Subject: Issuance of Amendment No. 3 to Facility Operating  
License No. NPF-57 - Hope Creek Generating Station

This amendment modifies the Hope Creek Technical Specifications to permit long-term operation with one recirculation loop out of service.

Amendment No. 3  
License No. NPF-57

ENCLOSURE TO LICENSE AMENDMENT NO. 3

Figure 3.2.1-1

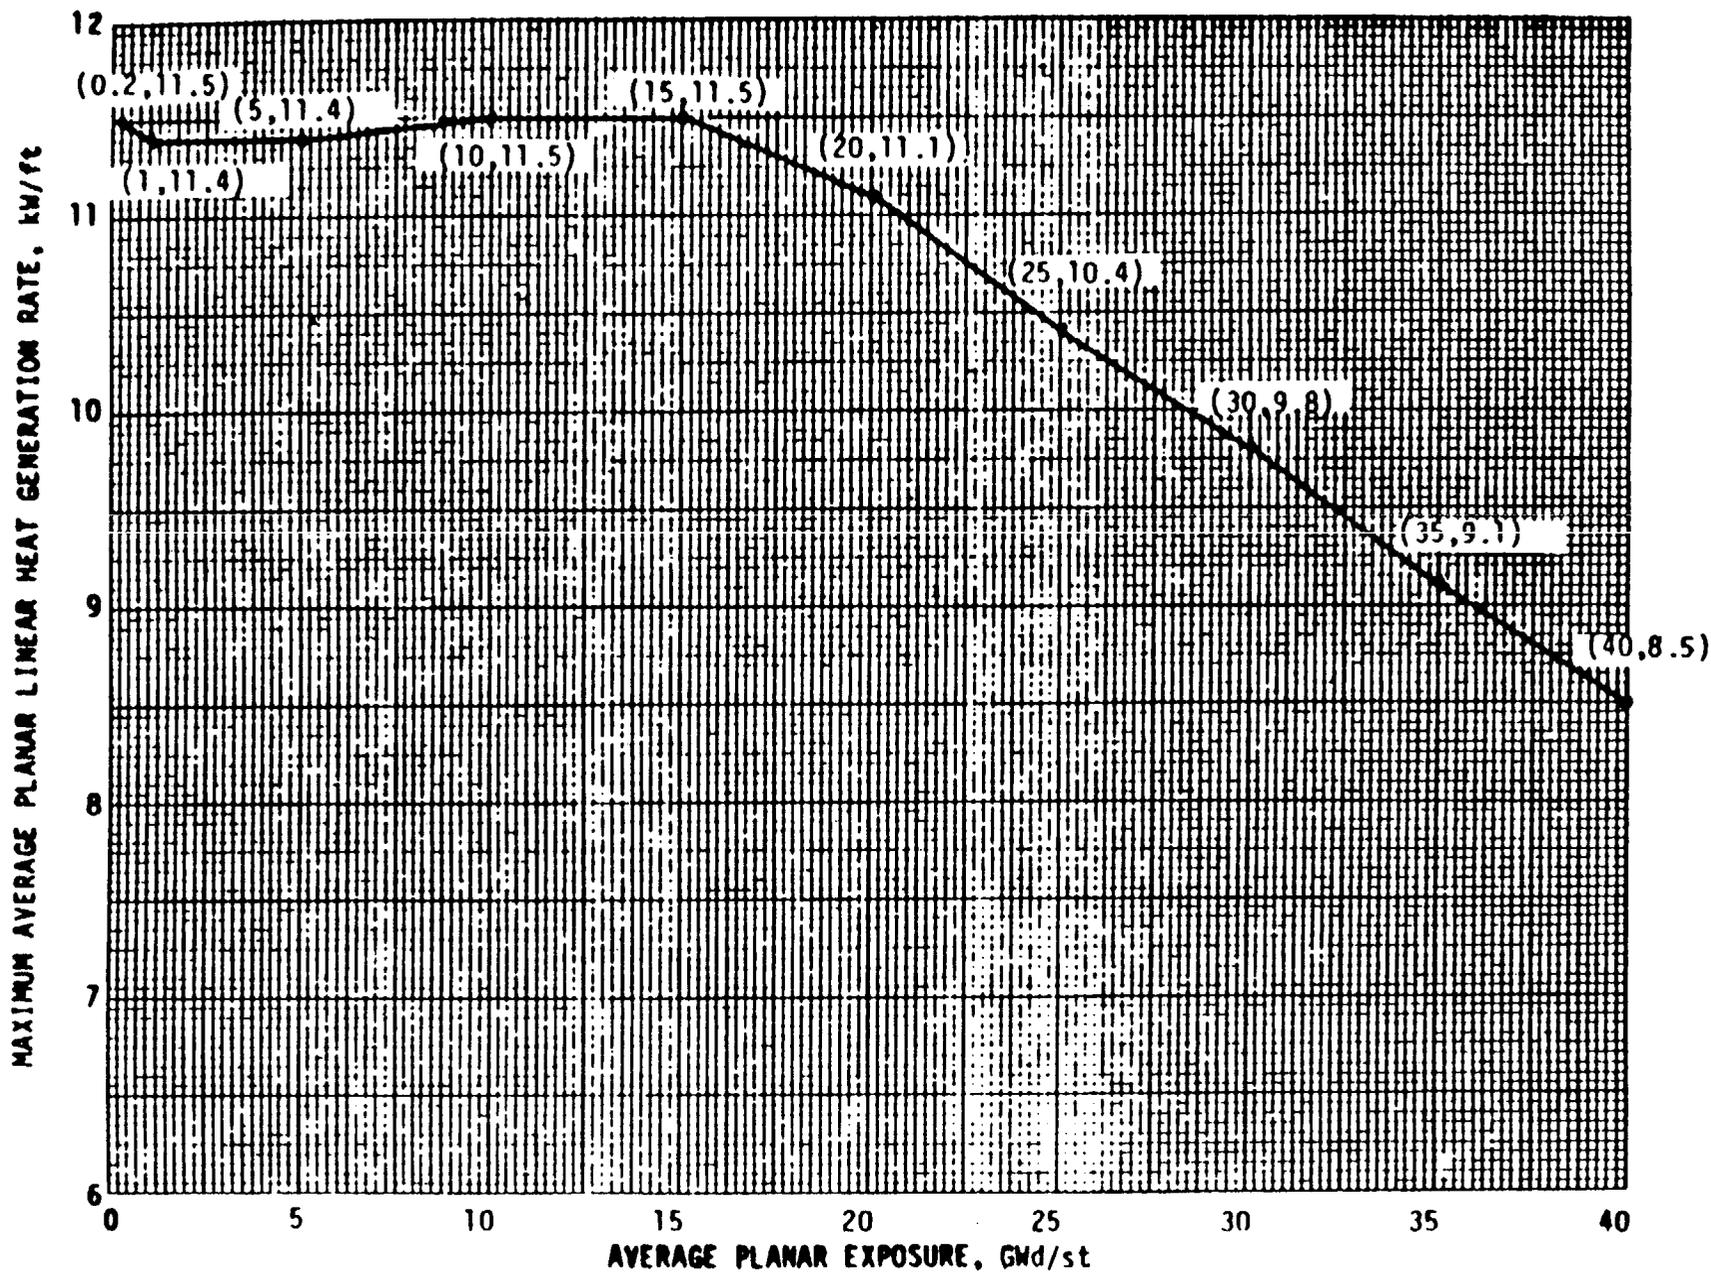
3.2.1 All AVERAGE PLANAR LINEAR HEAT GENERATION RATES (APLHGRs) for each type of fuel as a function of AVERAGE PLANAR EXPOSURE shall not exceed the limits shown in Figures 3.2.1-1, 3.2.1-2, 3.2.1-3, 3.2.1-4, and 3.2.1-5. The limits of Figures 3.2.1-1, 3.2.1-2, 3.2.1-3, 3.2.1-4 and 3.2.1-5 shall be reduced to a value of 0.86 times the two recirculation loop operation limit when in single recirculation loop operation.

For plant operation with single recirculation loop, the MAPLHGR limits of Figures 3.2.1-1, 3.2.1-2, 3.2.1-3, 3.2.1-4 and 3.2.1-5 are multiplied by 0.86. The constant factor 0.86 is derived from LOCA analysis initiated from single loop operation to account for earlier transition at the limiting fuel node compared to the standard LOCA evaluations.

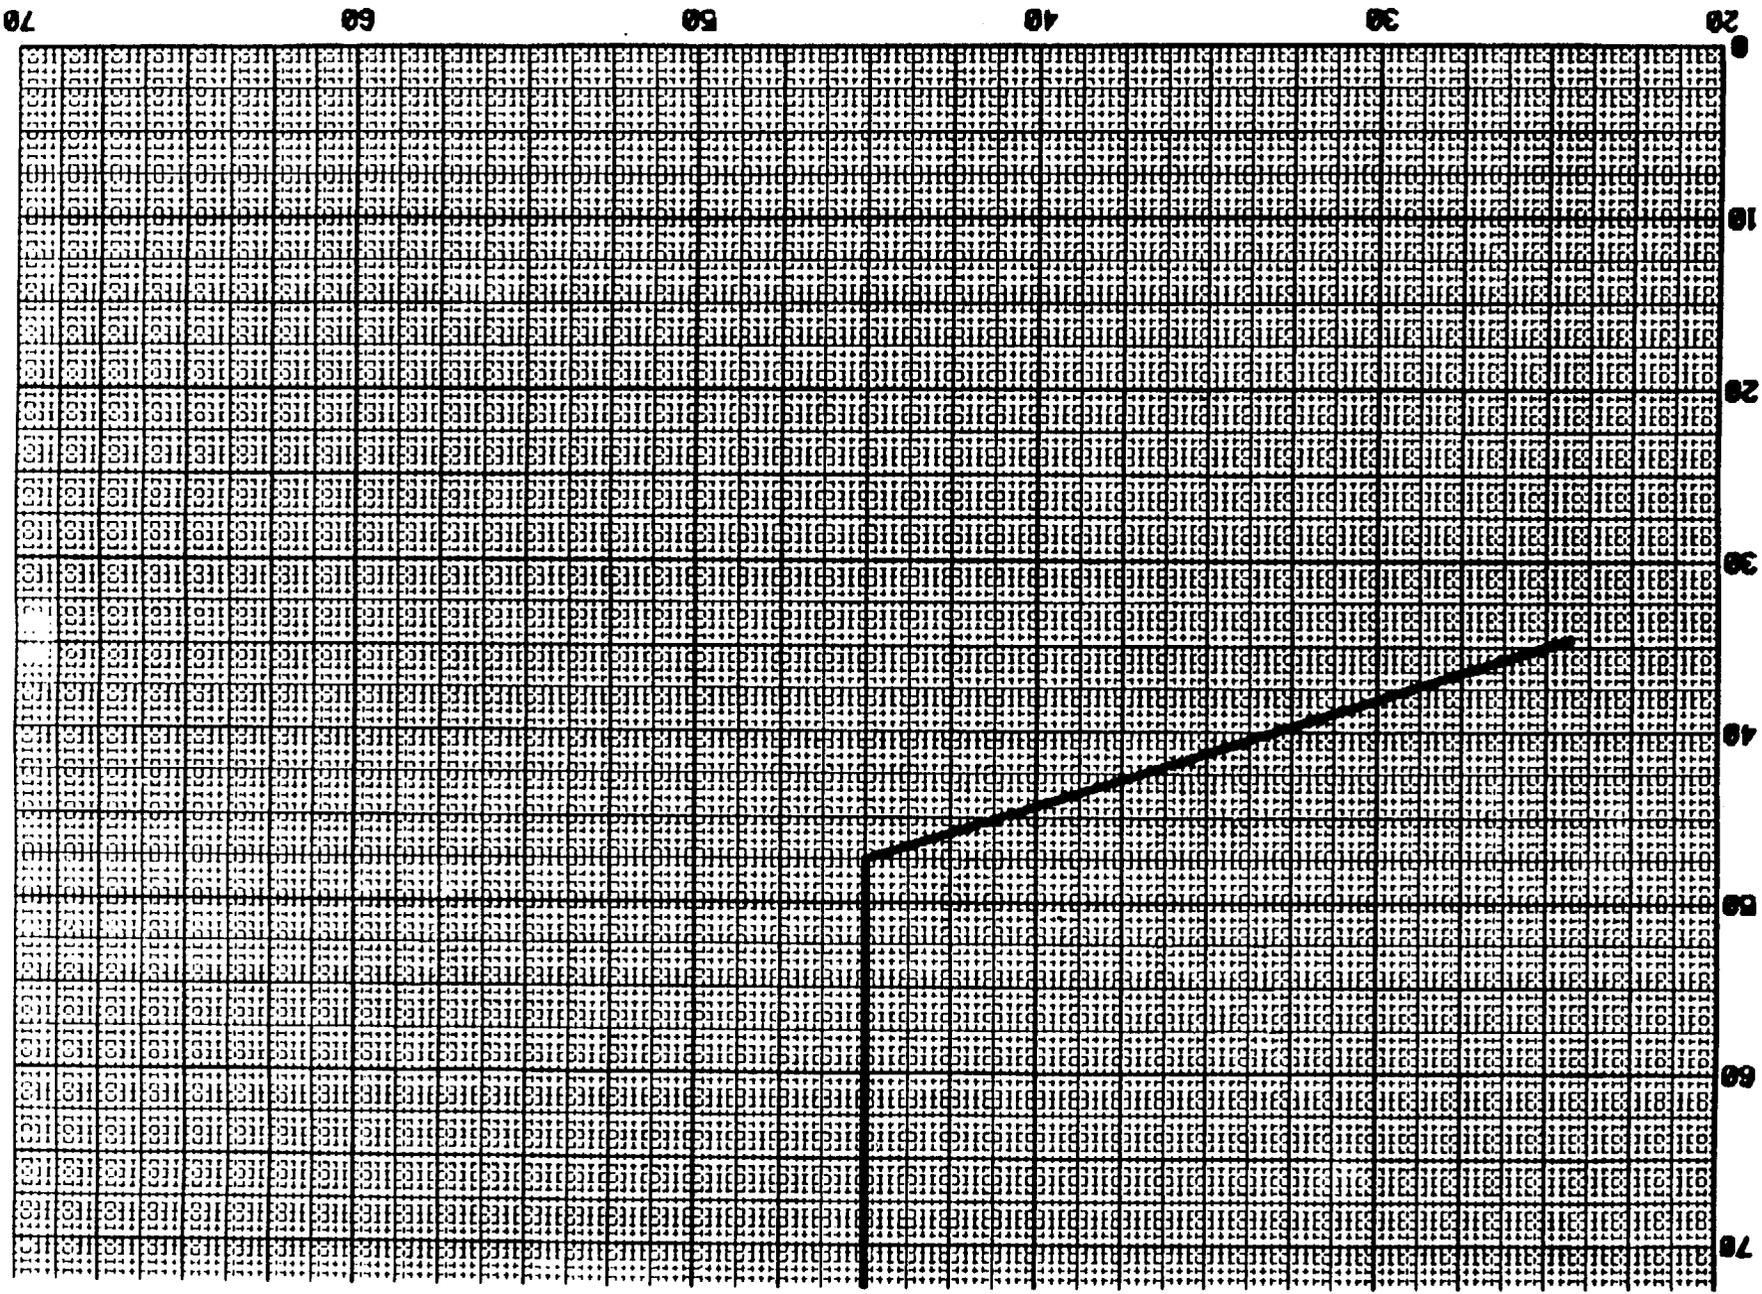
7. Revision of the section describing the recirculation system recirculation loops, T.S 3/4.4.1 to include SLO.
8. Revision of Figure 3.4.1.1-1, which illustrates thermal power vs. core flow to be compatible with the TS.

- a. Total core flow greater than or equal to 45% of rated core flow, or
- b. THERMAL POWER less than or equal to the limit specified in Figure 3.4.1.1-1.

- d. With one or two reactor coolant system recirculation loops in operation and total core flow less than or equal to 39%# and THERMAL POWER greater than the limit specified in Figure 3.4.1.1-1, within 15 minutes initiate corrective action to reduce THERMAL POWER to less than or equal to the limit specified in Figure 3.4.1.1-1 or increase core flow to greater than 39%# within 4 hours.
